HISTORIC AND DESIGN REVIEW COMMISSION

HDRC CASE NO: 2017-636
ADDRESS: 423 N HACKBERRY ST
LEGAL DESCRIPTION: NCB 576 BLK 15A LOT N 30.32 FT OF 12
ZONING: RM-4 H
CITY COUNCIL DIST.: 2
DISTRICT: Dignowity Hill Historic District
APPLICANT: John Brearley
OWNER: John Brearley
TYPE OF WORK: Construction of a 2-story single family home
APPLICATION RECEIVED: December 01, 2017
60-DAY REVIEW: January 30, 2018
REQUEST:

The applicant is requesting a Certificate of Appropriateness for approval to construct a 2-story single family home on the vacant lot at 423 N Hackberry.

FRONT ELEVATION

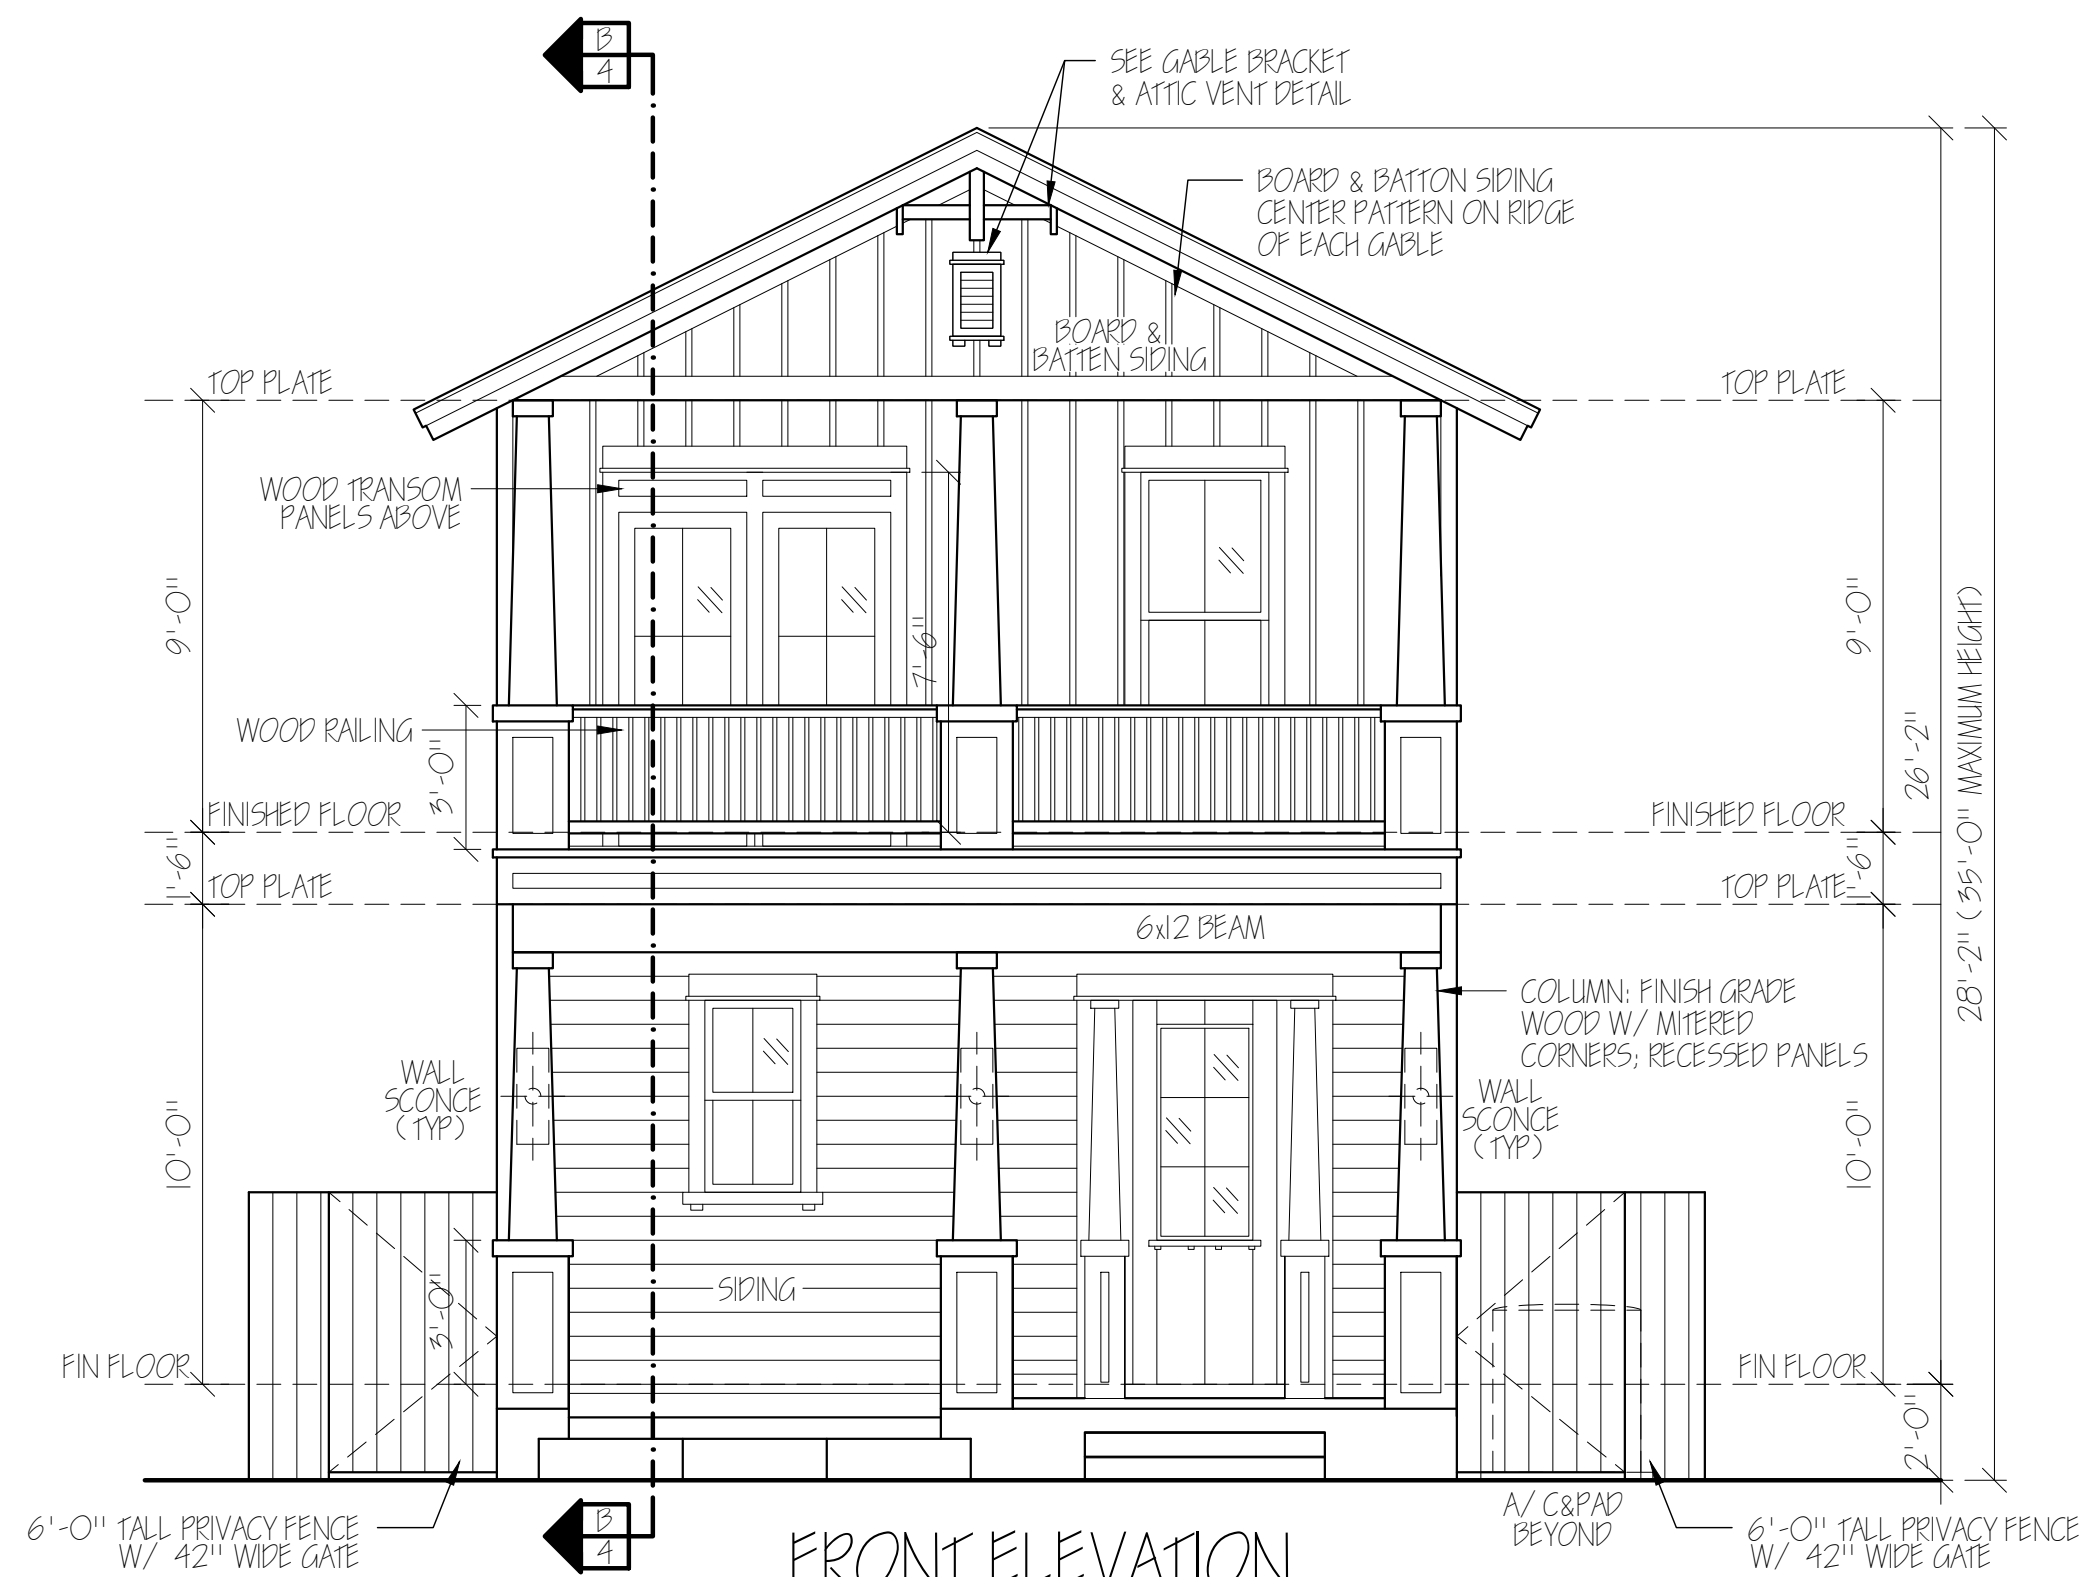
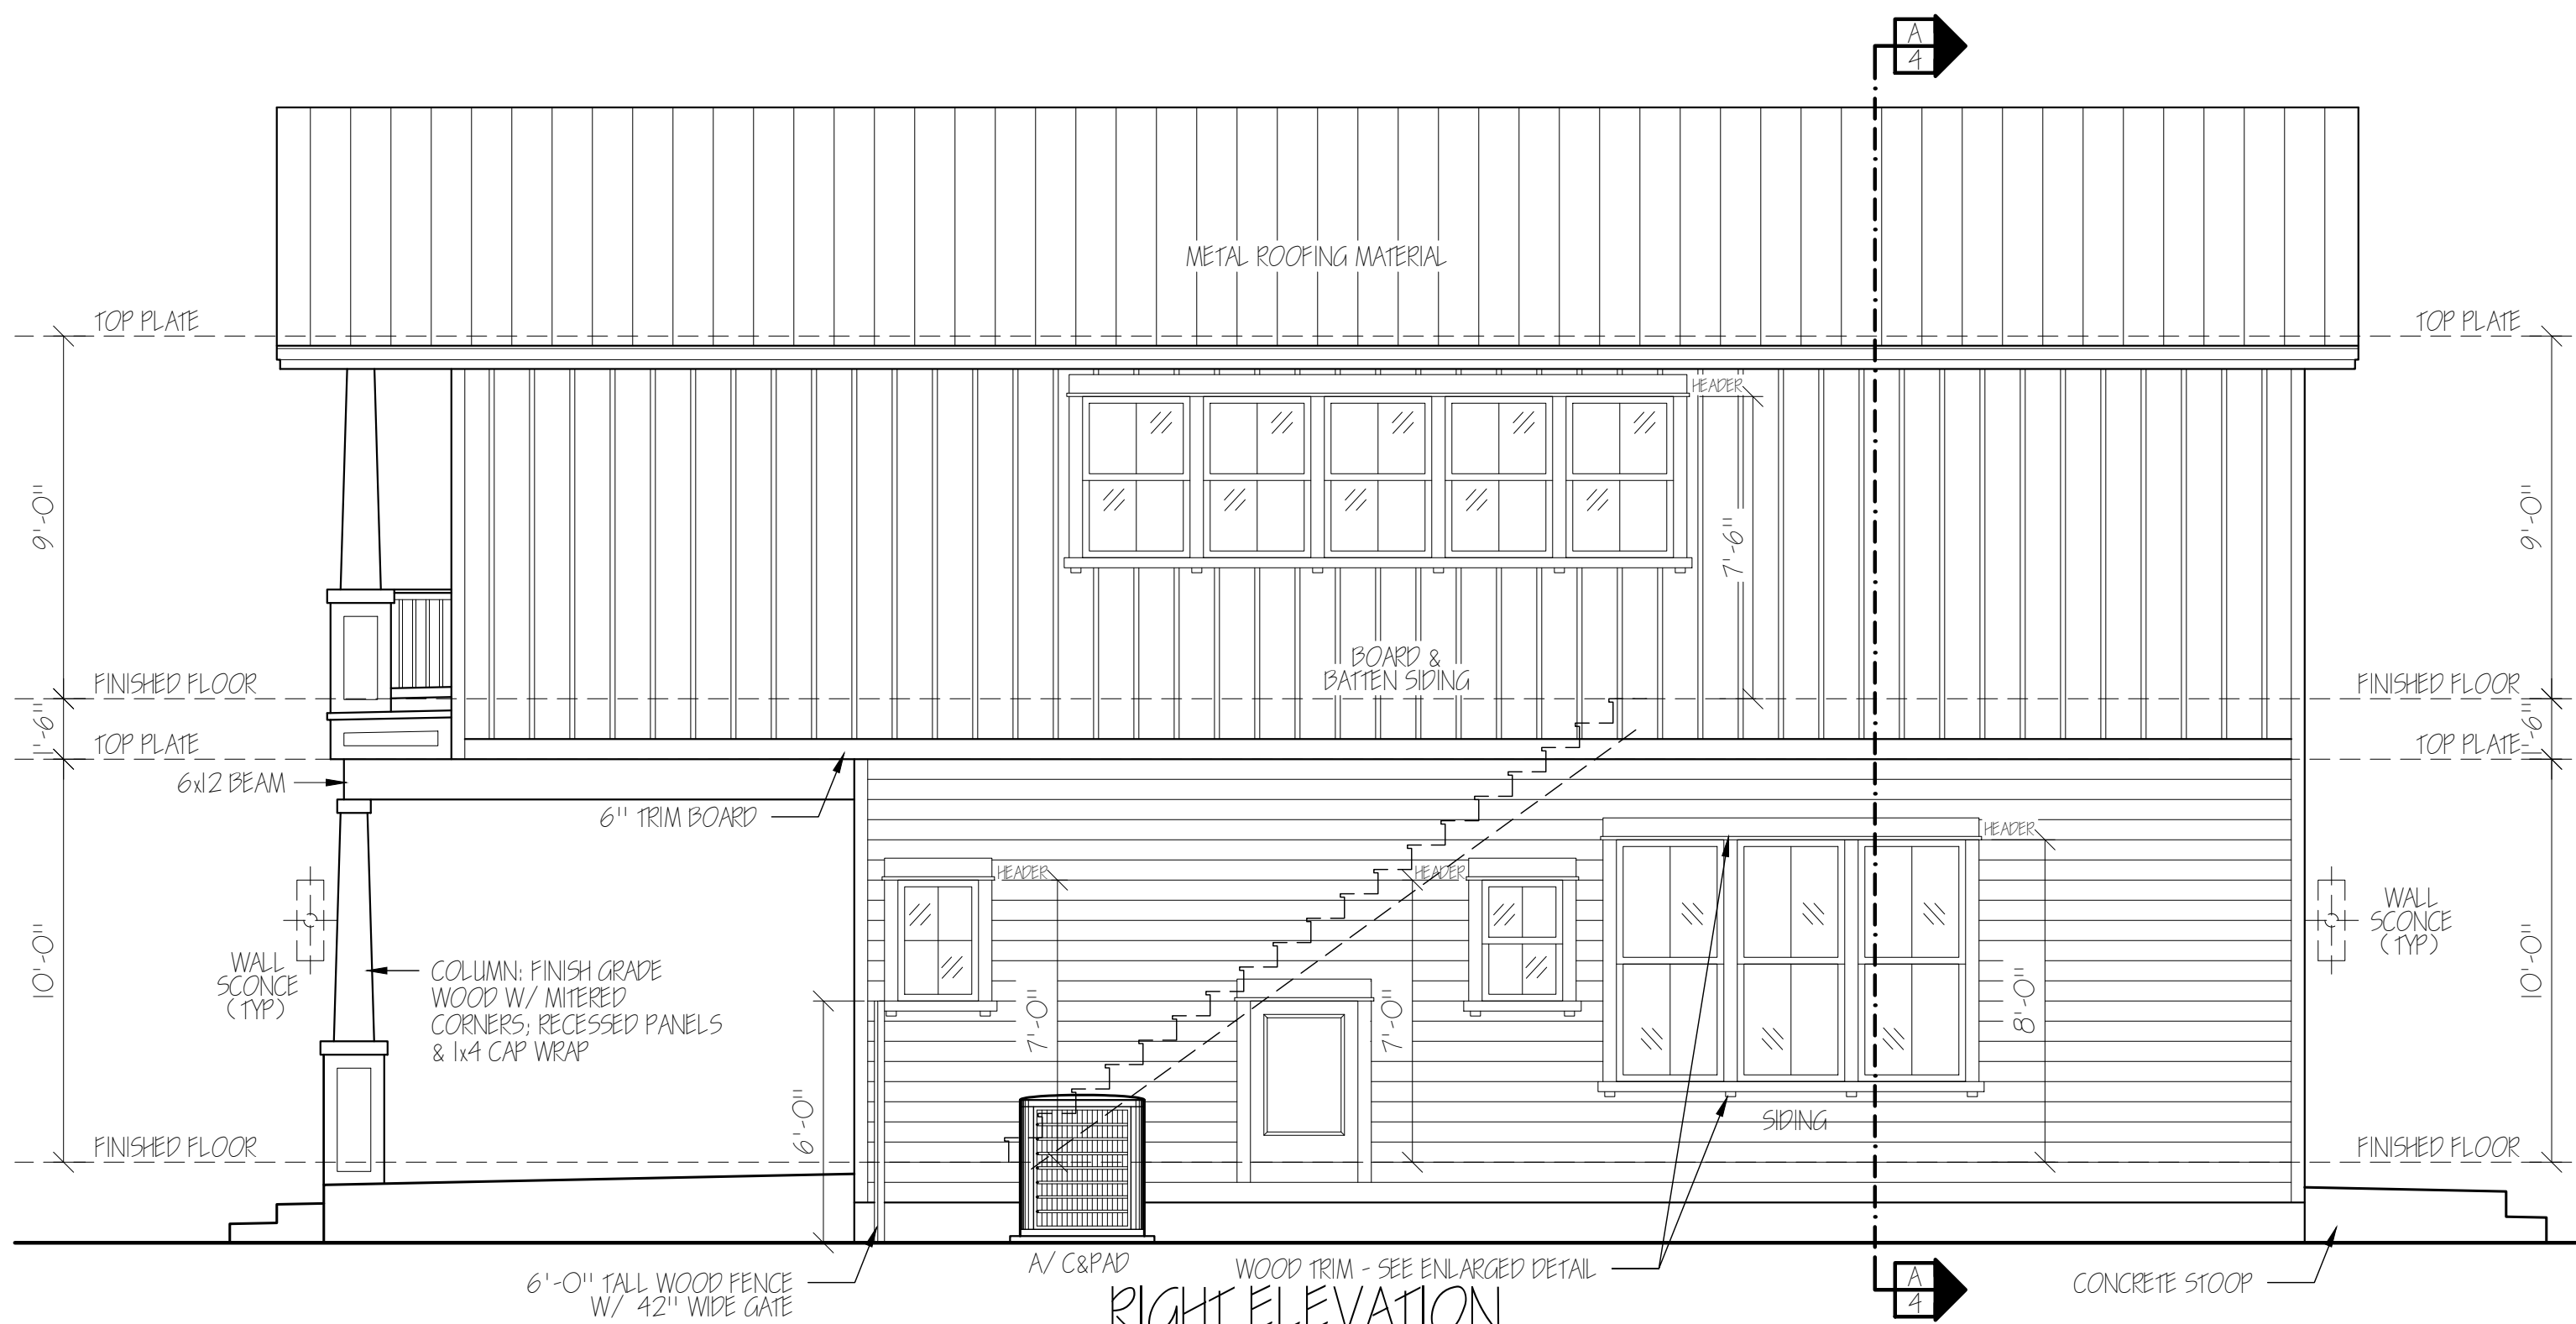
- f. **PORCH CONFIGURATION AND MASSING** – The applicant has proposed to incorporate a front porch on the front façade of the new structure. The porch mass will be inset approximately 6" from the front façade. The Historic Design Guidelines state that porches on new construction should be reflective of the development pattern of the district. Typically in historic districts, including Dignowity Hill, residential porch massing elements project the furthest towards the streetscape to engage pedestrians. Two story structures feature a second story that is set back from the porch. As proposed, the structure's second story extends over the front porch, which increases the massing on the street. This is addressed in Guideline 2.A.ii, which states that step-downs in building height,

wallplane offsets, and other variations in building massing to provide a visual transition should be utilized. There is no historic precedent in the district for this porch form or massing strategy. Staff finds the porch inconsistent with the Guidelines.

- p. **DRIVEWAY & PARKING** – The applicant has proposed a new front concrete ribbon driveway measuring approximately 10'-8" in length and approximately 10'-0" in width. The concrete terminates at the front façade of the proposed new structure's carport and transitions into crushed granite. According to the Historic Design Guidelines, new garages should follow the historic pattern of similar structures along the streetscape or district for new garages and outbuildings. Historic garages and outbuildings are most typically located at the rear of the lot, behind the principal building. There is no historic precedent for an attached garage in the Dignowity Hill Historic District. The development pattern in the Dignowity Hill Historic District is most commonly for driveways to extend through the front yard to the side and rear yard of historic properties. Staff does not find the proposed front-loaded parking and driveway location to be consistent with the Guidelines or with the development pattern of the district.

COMMENTS/CONCERNS: Updated drawing - includes
small front balcony. Plus a fake window
under carport. Issue of no windows on one
side; issue of a fake window in new construction.
Needs to have windows. Small window in bathroom,
not large enough - focus on pattern, consistency.
Fewer windows placed strategically.
Balance pattern, rigidity to window placement. →

Longer windows downstairs. One over one in carport.

Head ~~light~~ height: bring down to match, down to seven ~~feet~~ feet.

- i. That the applicant proposes an alternative solution for the driveway and parking configuration that responds to the predominant historic development pattern in the district and maintains a traditional porch form instead of the proposed covered parking.
